IMPORTANT NOTICE

This letter is in regard to our **RAIDAR Snake Defence** units. It is of high importance you read this letter and contact us if there is any confusion.

As of December 2014, ALL **RAIDAR Snake Defence** units (both MP PLUS & MP Lite Plus) will come as a 5V unit.

3Volt Connection Fig 1

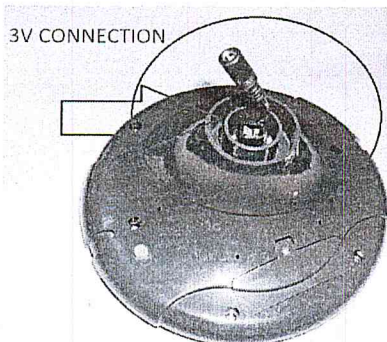
Currently all **RAIDAR MP PLUS Snake Defence** units come as 3V units.

The 3V unit is only in the MP Plus (dark green head) and is easily recognised by either a 3V label on the section that fits into the stake or visually as shown in Fig 1 because it has a plug connection for the AC adaptor in the middle and an extended plug for the stake connection.

If an AC adaptor is required then the customer will need to be able to determine if the unit is 3V or 5V.

5V Connection Fig 2

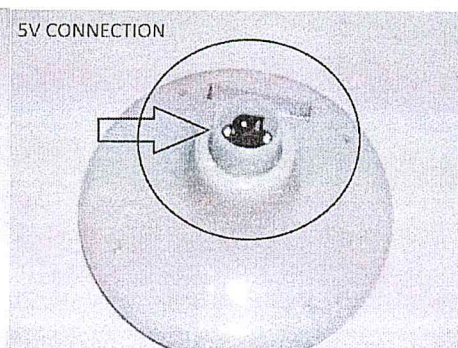
The 5V units (the new LITE unit and the Latest MP Plus dark green unit) only have a single plug point that takes both the AC adaptor and the stake as shown in Fig 2 & Fig 3.

It is absolutely critical that this is understood to avoid customers receiving the incorrect adaptor when purchasing one for their Snake Defence unit, as providing the incorrect adaptor may lead to serious damage to the Snake Defence unit.
